March 13, 2015

Re: Permit No. M-1989-120— Platte Valley
Technical Revision Request - Phase 2 Backfill

Aggregate Industries-WCR, Inc. – Platte Valley Site – S. Platte River Erosion

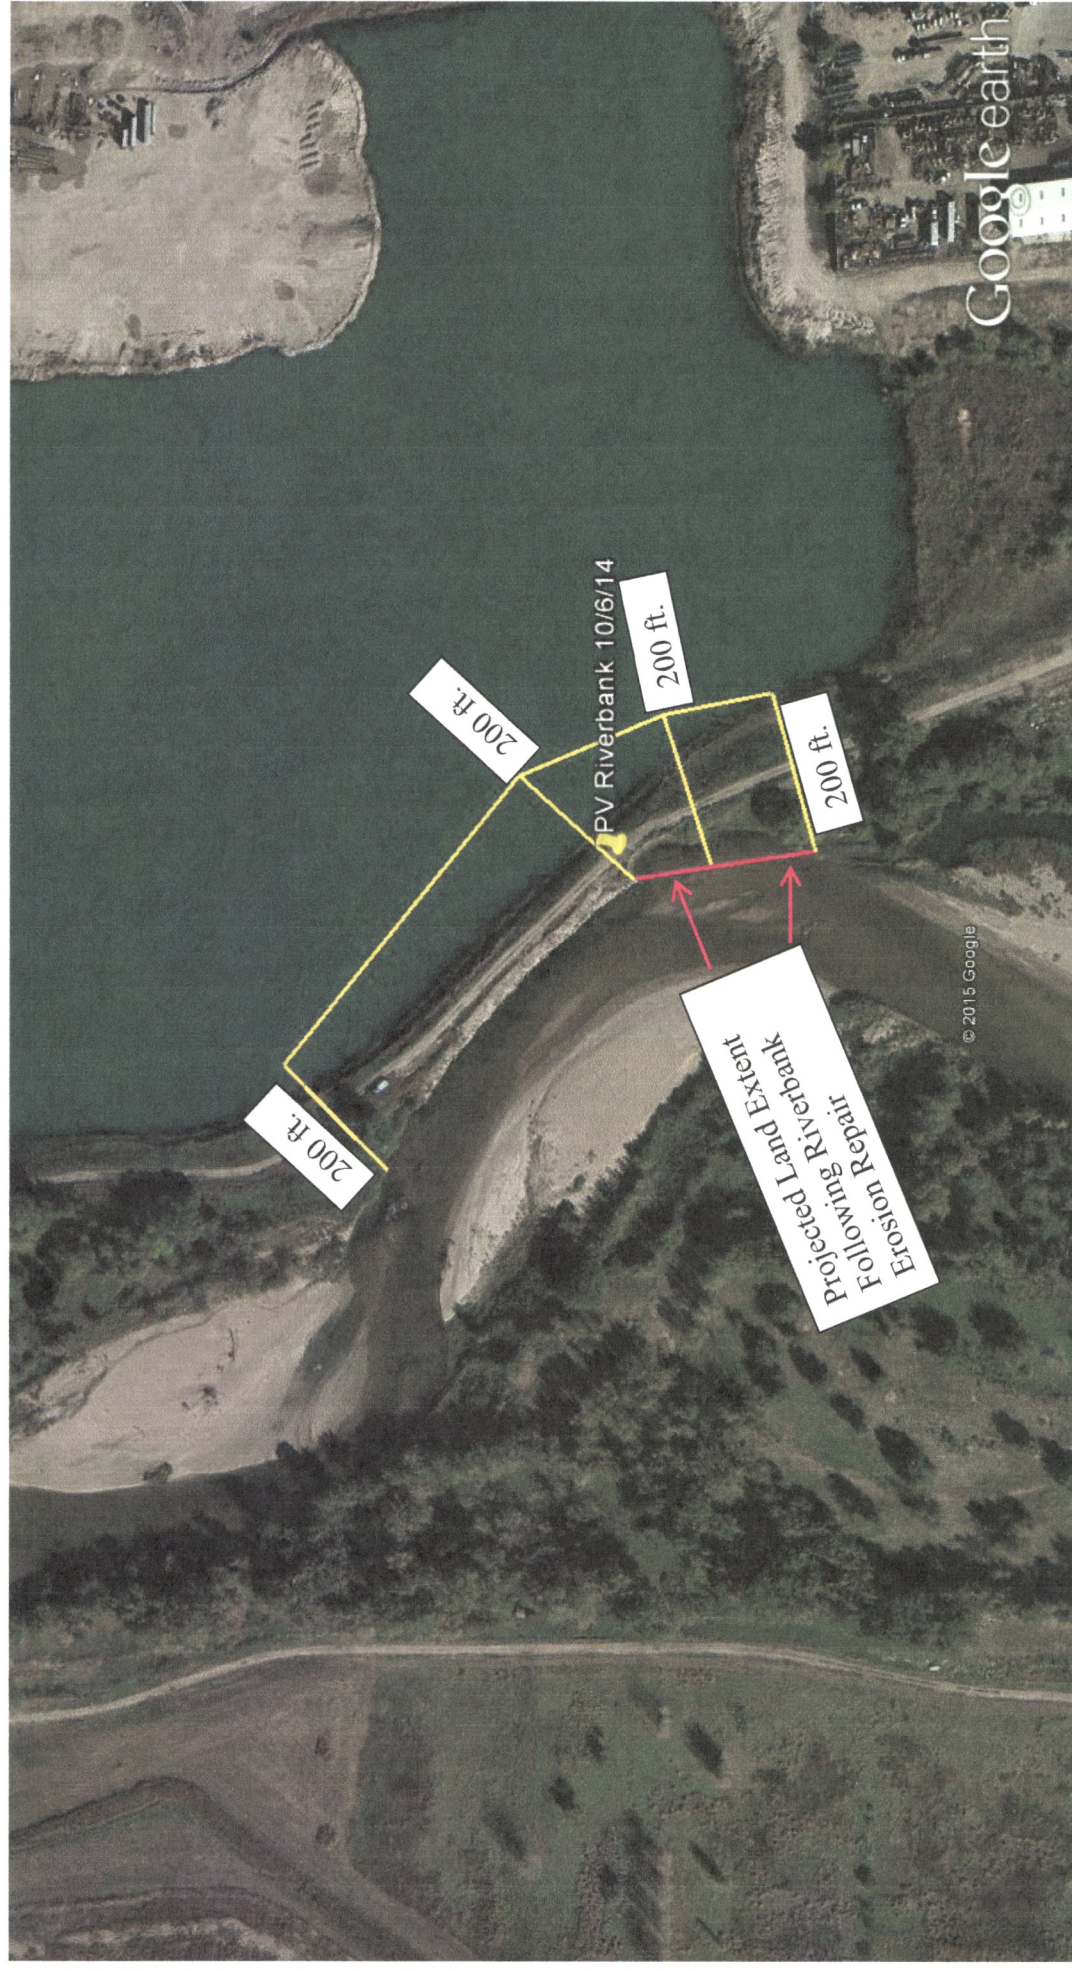
- Restore property to the approximate original land extent for a distance of approximately 200 lineal feet along the east bank of the South Platte River.
- Build slope from the re-established land extent to the river with clean, inert fill and steel-free concrete rubble.
- Cap slope with two-foot thick layer of clean, steel-free concrete rubble.
- Topsoil and vegetate disturbed area typical of other Aggregate Industries' river stabilization and restoration projects.

The NWP 3 project area is identified on the attached Google Earth aerial photos from May 2011 and October 2014, which show the pre and post erosion status of the land.
